Access Compliance Report

Public Rights-of-Way

(Curb Ramps)

Intersection ID: 49297	Main Street: CAMPBELL_HALL_CT	Cross Street: CHAMBERLIN_RD	Location: NW
ADA ID: ACFD2E09F29B	Ramp Type: Perp	Initial Pass/Fail: Pass	Overall Compliance: No
Severity Score: 15			
Codes/Mitigation Info/Possible Solution		Field Measurements/Component Compliance

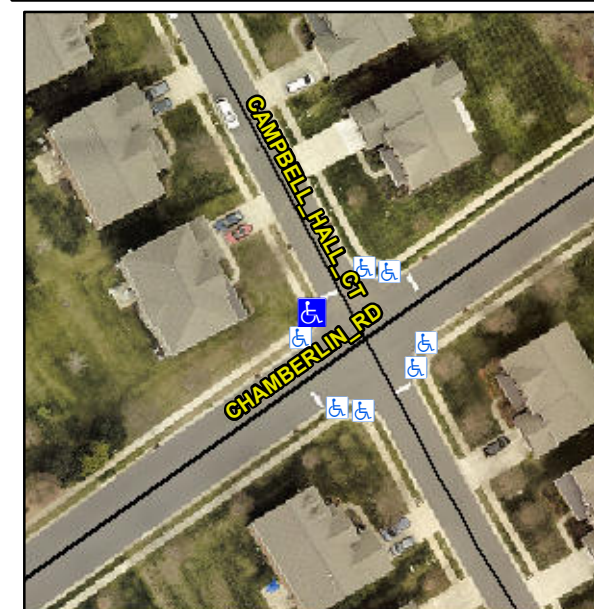
Not Found, R304.2.1, R304.2.2-Perp, R304.3.2-Para, R305.2, R302.7.2

Compliance	Description	Data	Compliance	Description	Data
N/A	Ramp Length (in)	47.0	Yes	Ramp Slope (%)	7.4
Yes	Ramp Width (in)	48.0	Yes	Ramp XSlope (%)	0.4
N/A	Flare Type LT	Sloped	N/A	Flare Type RT	N/A
N/A	Flare Slope LT (%)	7.8	Yes	Flare Slope RT (%)	6.5
N/A	Flare Traversable LT?	Yes	N/A	Flare Traversable RT?	Yes
No	Landing Length (in)	47.0	Yes	DWS Provided?	Yes
Yes	Landing Width (in)	48.0	Yes	DWS Contrast?	Yes
No	Landing Slope (%)	3.3	Yes	DWS Length (in)	24.5
Yes	Landing X Slope (%)	1.3	Yes	DWS Full Width?	Yes
N/A	Landing Curb? (Y/N)	No	No	DWS Offset (in)	5.5
N/A	Shared Landing?	No			
Yes	Gutter Ponding?	No	Yes	Gutter Slope (%)	3.1
No	Gutter Lip Ht (in)	1.0	Yes	Gutter X Slope (%)	1.1
N/A	Painted X Walk1?	No	N/A	Painted X Walk2?	N/A
	X Walk 1 Direction	To NE		X Walk 2 Direction	N/A
N/A	X Walk 1 Width (in)	N/A	N/A	X Walk 2 Width (in)	N/A
	X Walk 1 Slope (%)	0.5		X Walk 2 Slope (%)	N/A
	X Walk 1 X Slope (%)	0.3		X Walk 2 X Slope (%)	N/A

N/A	Ramp inside XWalk1?	N/A	N/A	Ramp inside XWalk2?	N/A
	Road Slope (%)	N/A	N/A	Clear Space?	Yes
	Road X Slope (%)	N/A	N/A	Clear Space to XWalk (in)	N/A
Yes	Any Obstructions?	No	Yes	Storm Grate/Utility Hazard?	No
	Obstruction Type			Storm Grate/Utility Type	
		N/A			N/A
			Yes	Surface Condition? (G/P)	Good

Remove & Replace Entire Ramp.
